PRELIMINARY DRAINAGE REPORT

GRANDVIEW RESERVE

Add text:
PCD Filing No.:
PUDSP2110

Cursory comments - see
comment letter also.

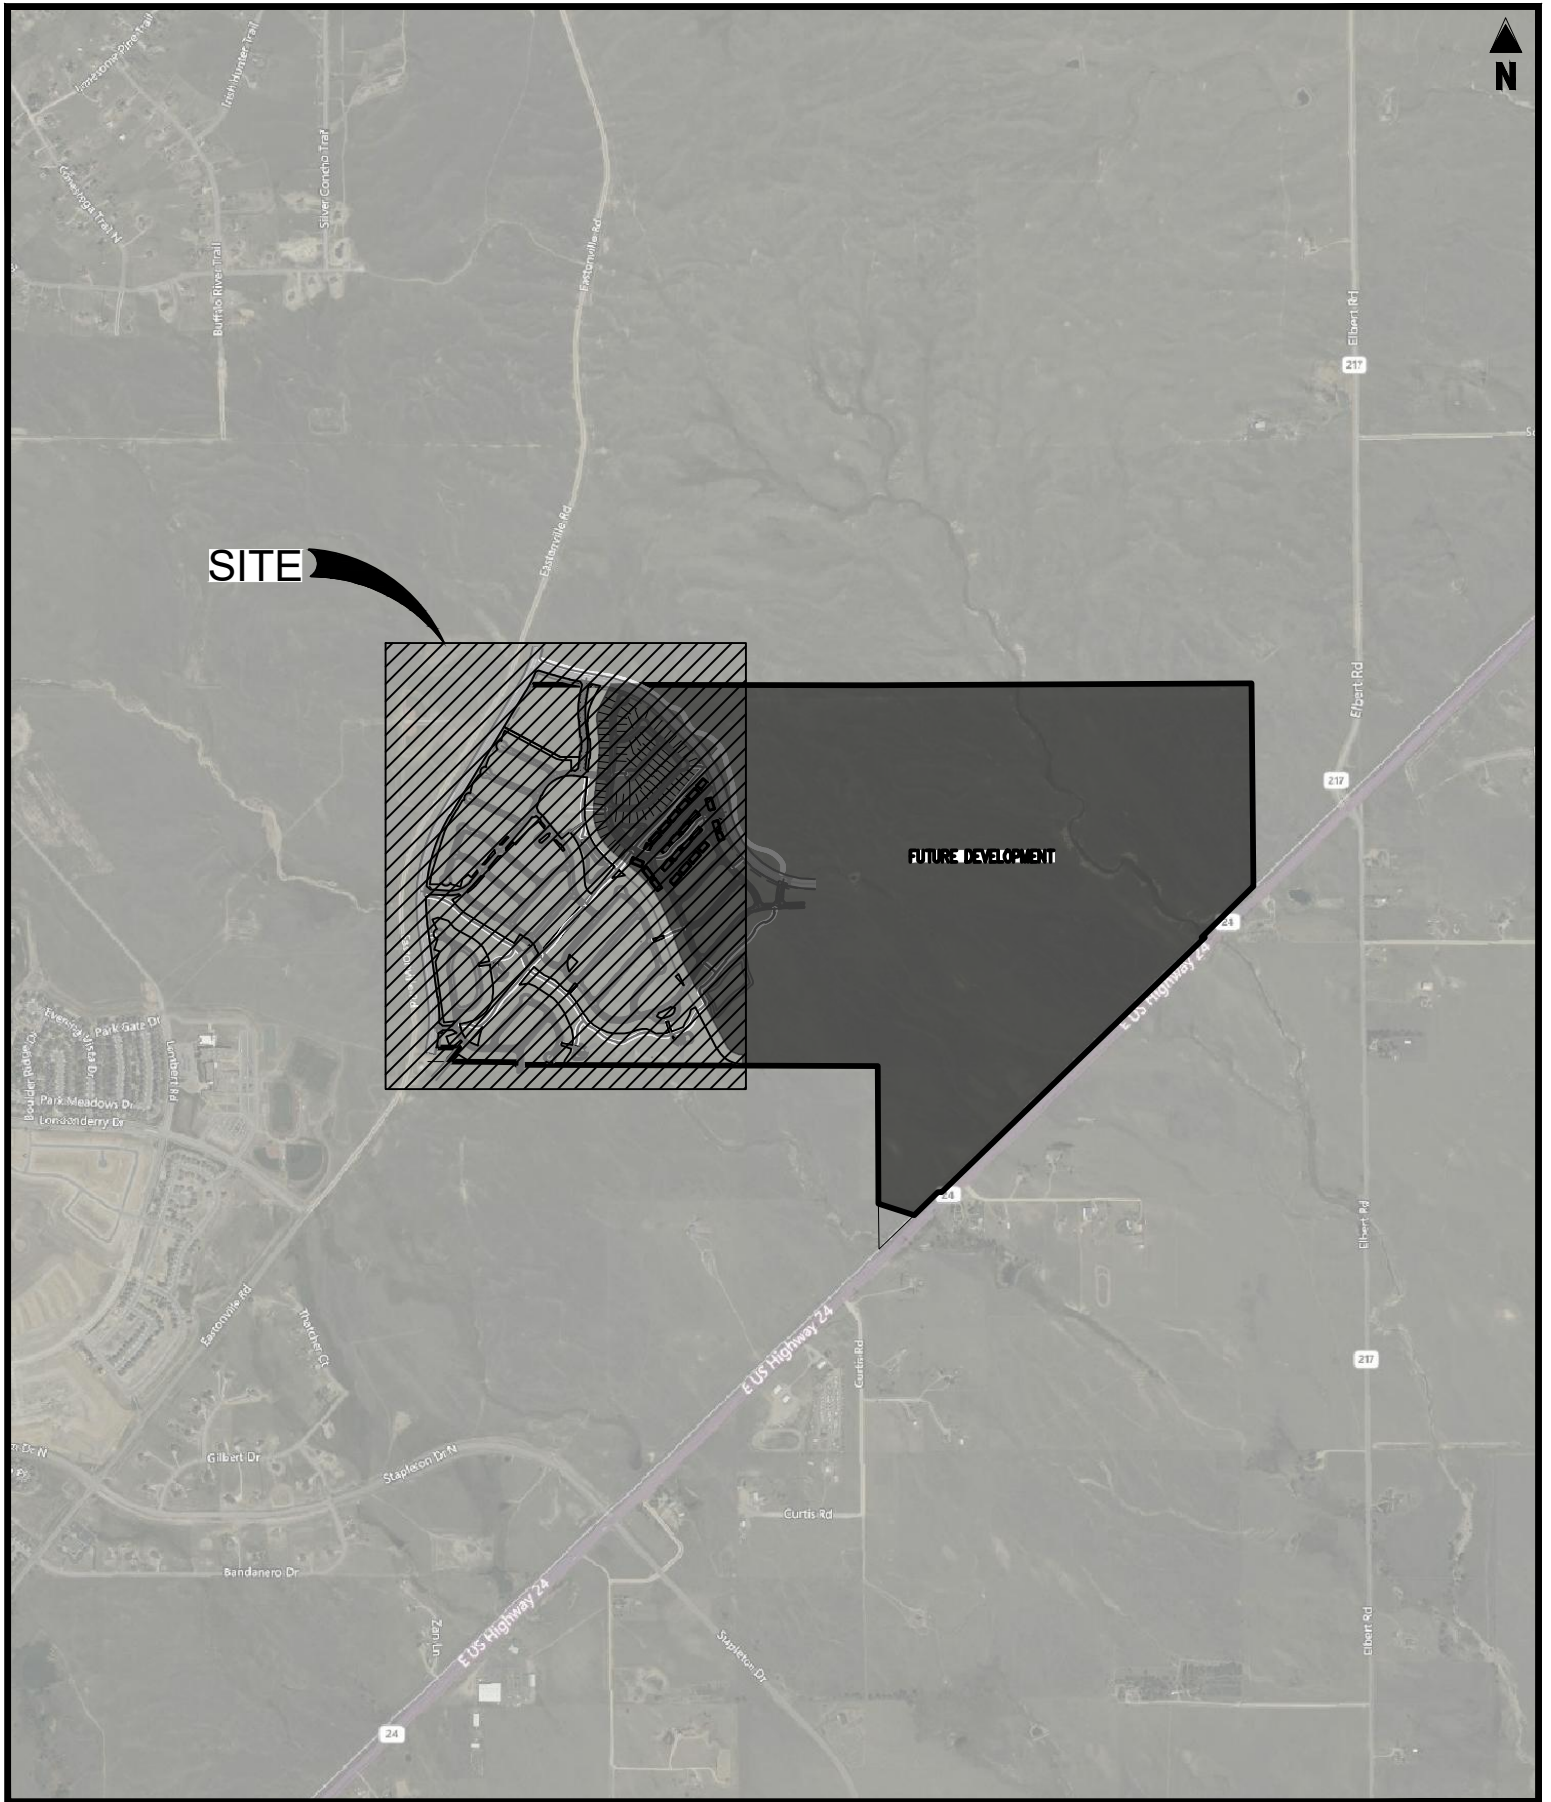
Add EPC DCM Update (2015) and ECM (2020)

DETENTION BASIN STAGE-STORAGE TABLE BUILDER

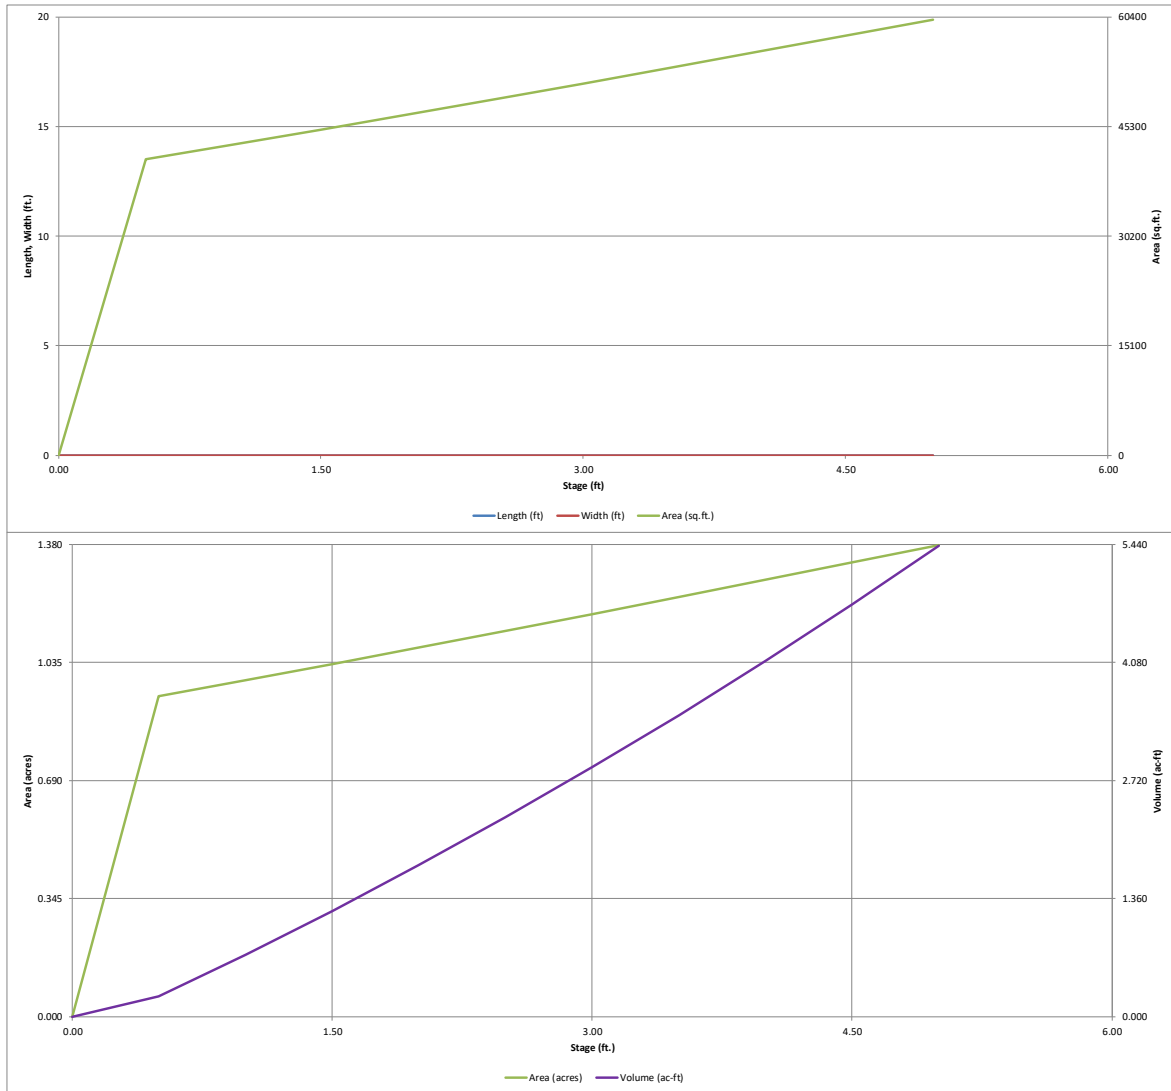
Provide the outlet design sheets for each pond

Project No: HRG 1.20
Drawn By: NJA
Checked By: GRD
Date: 8/12/2021
WQ MAP

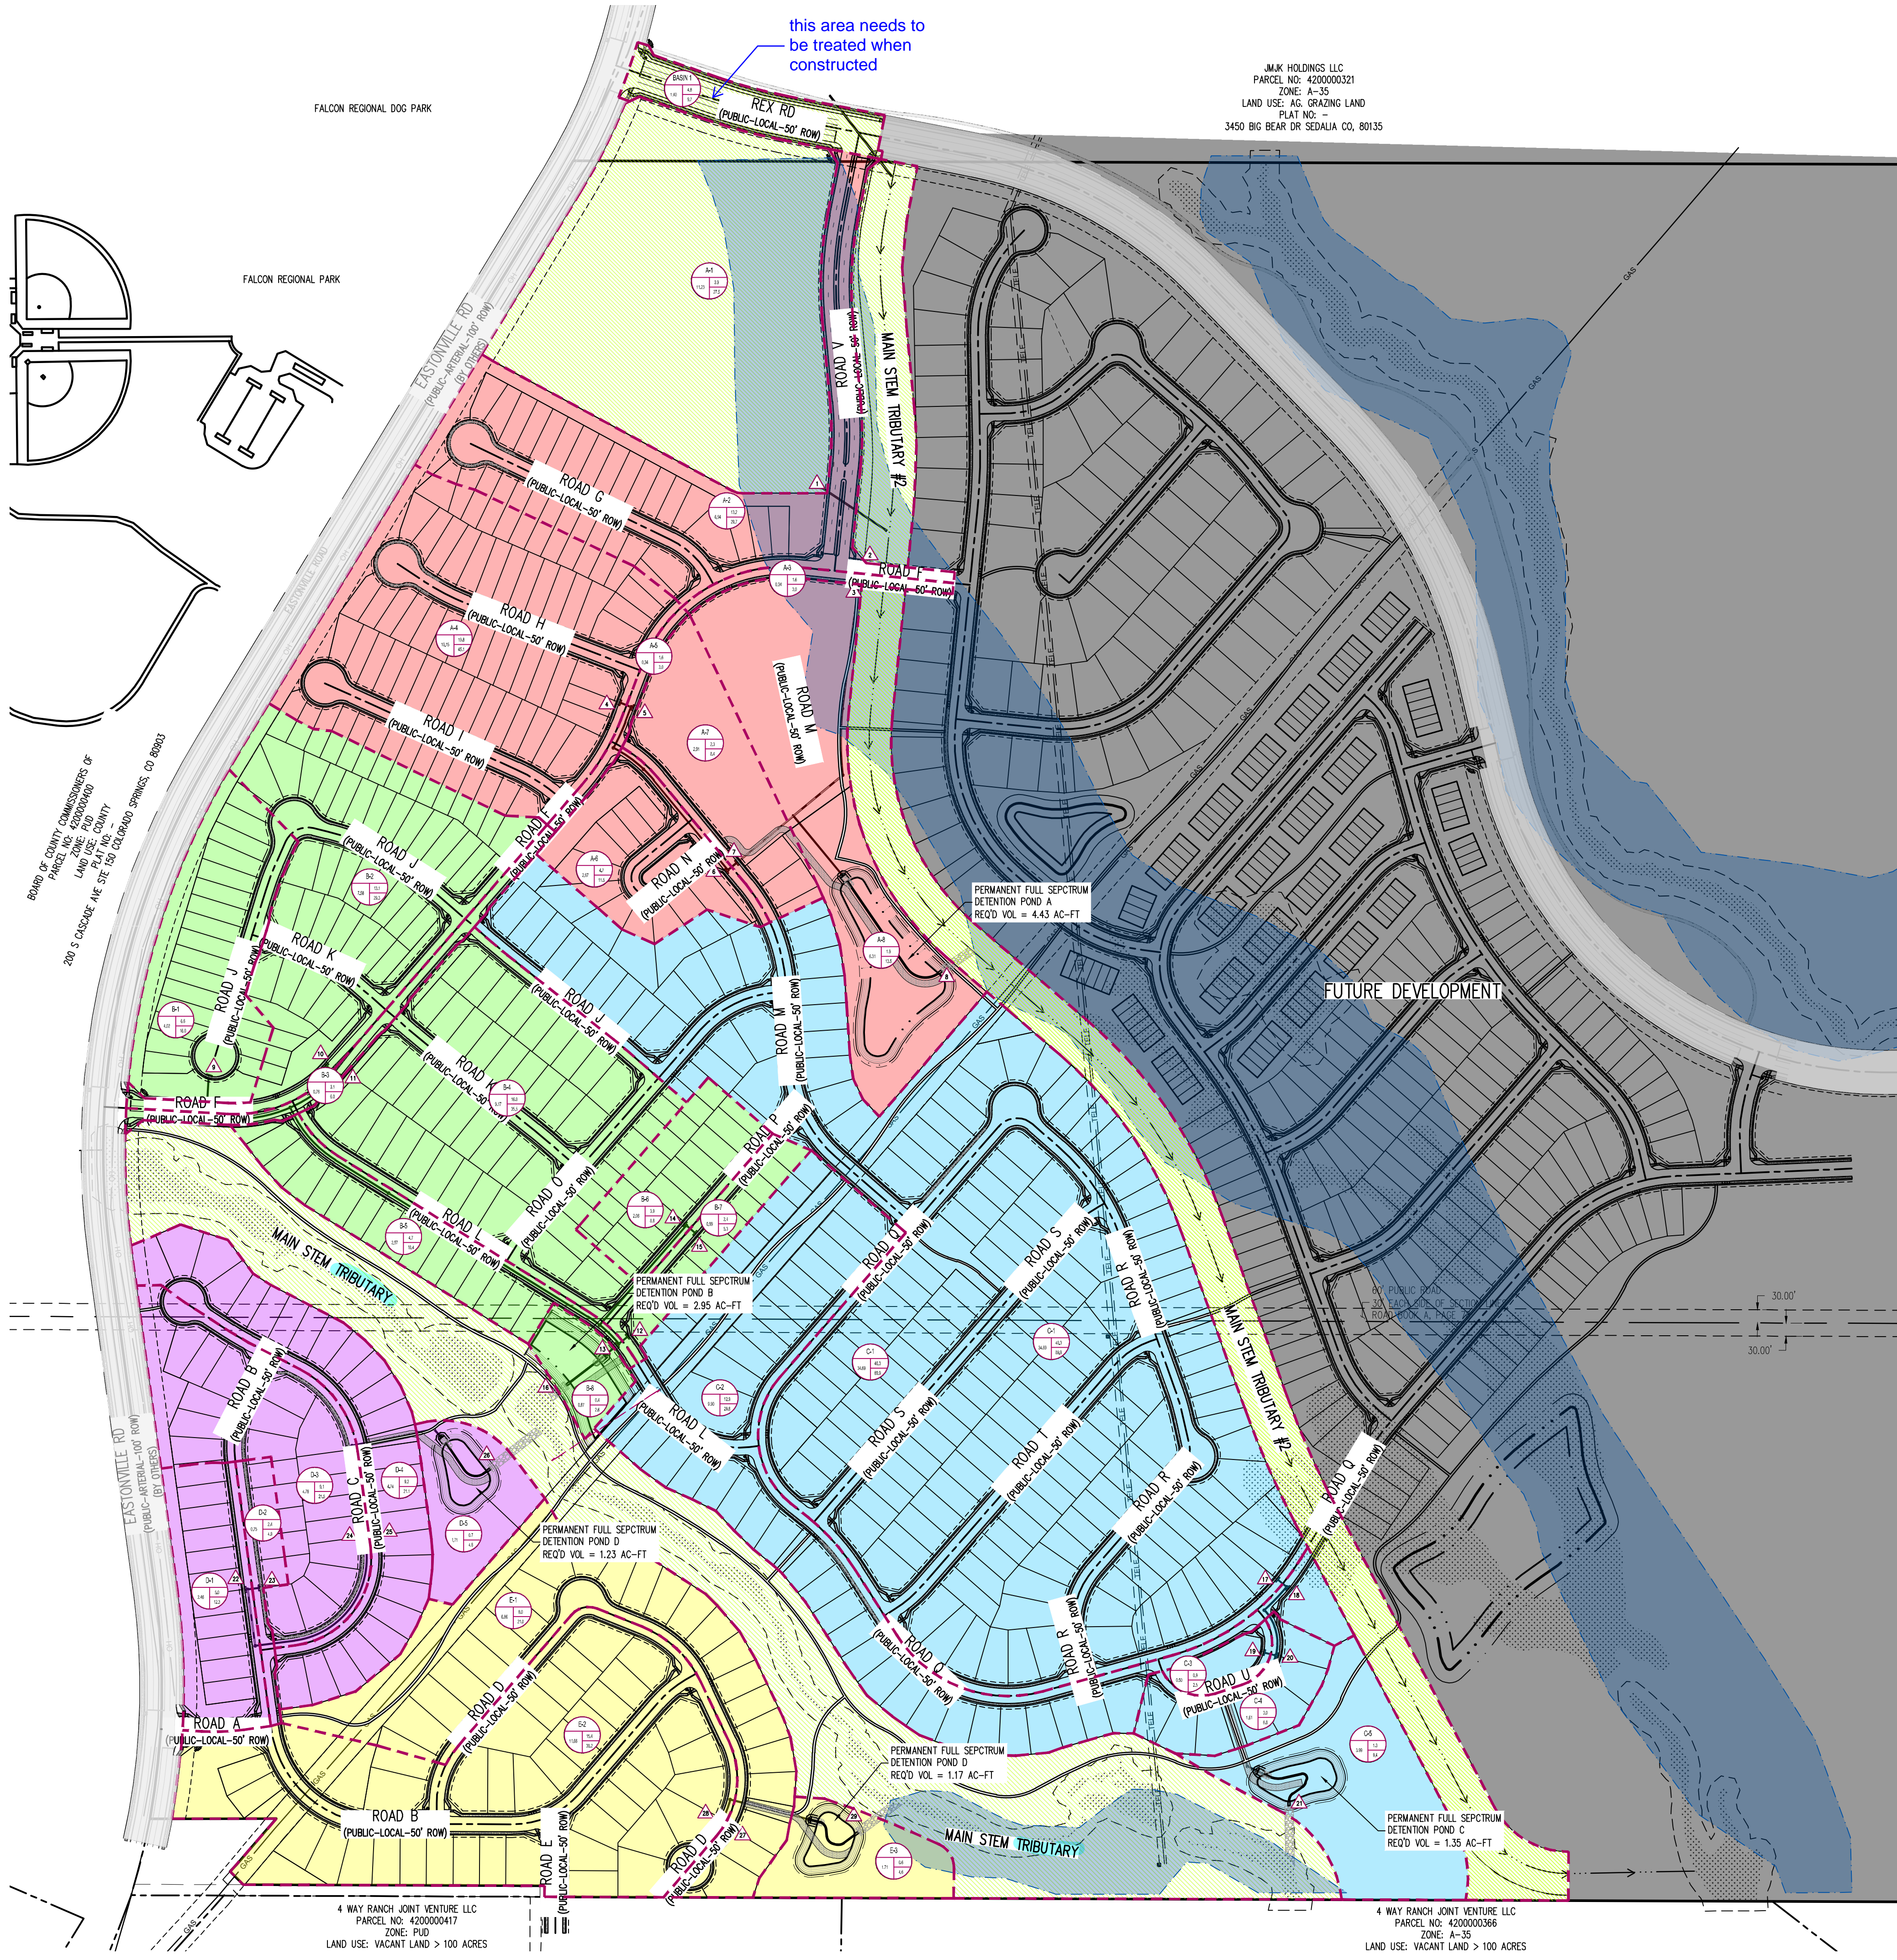
this area needs to be treated when constructed

revise scale. Previous maps are 1"=100', this map has a different scale than those.
